PIC16(L)F1946/1947 Family Silicon Errata and Data Sheet Clarification

The PIC16(L)F1946/1947 family devices that you have received conform functionally to the current Device Data Sheet (DS41414B), except for the anomalies described in this document.

FIGURE 1: INSTRUCTION CYCLE DELAY CALCULATION EXAMPLE

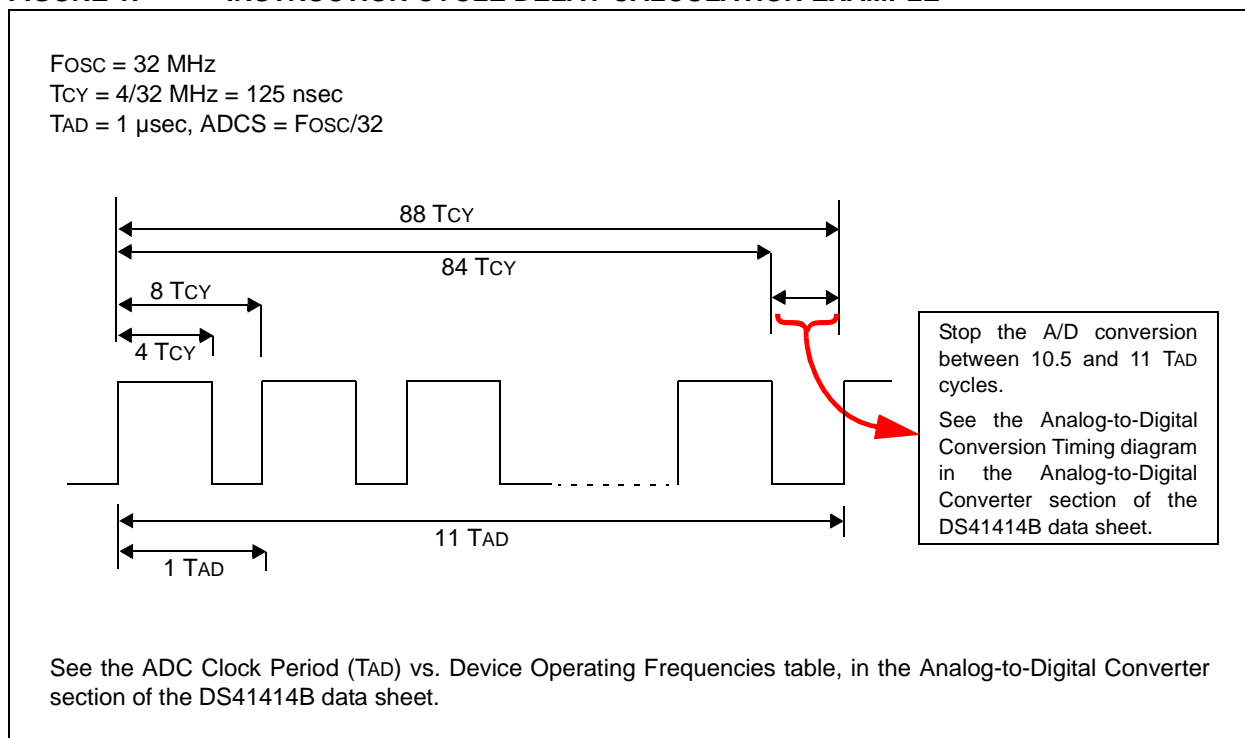
Under certain device operating conditions, the ADC conversion may not complete properly. When this occurs, the ADC Interrupt Flag (ADIF) does not get set, the ADGO/DONE bit does not get cleared and the conversion result does not get loaded into the ADRESH and ADRESL result registers.

Method 2: Provide a fixed delay in software to stop the A-to-D conversion manually, after all 10 bits are converted, but before the conversion would complete automatically. The conversion is stopped by clearing the GO/DONE bit in software. The GO/DONE bit must be cleared during the last ½ TAD cycle, before the conversion would have completed automatically. Refer to [Figure 1](#) for details.

In Figure 1, 88 instruction cycles (Tcy) will be required to complete the full conversion. Each TAD cycle consists of 8 Tcy periods. A fixed delay is provided to stop the A/D conversion after 86 instruction cycles and terminate the conversion at the correct time as shown in the figure above.

Note: The exact delay time will depend on the choice of FOSC and the TAD divisor (ADCS) selection. The Tcy counts shown in the timing diagram above apply to this example only. Refer to Table 3 for the required delay counts for other configurations.
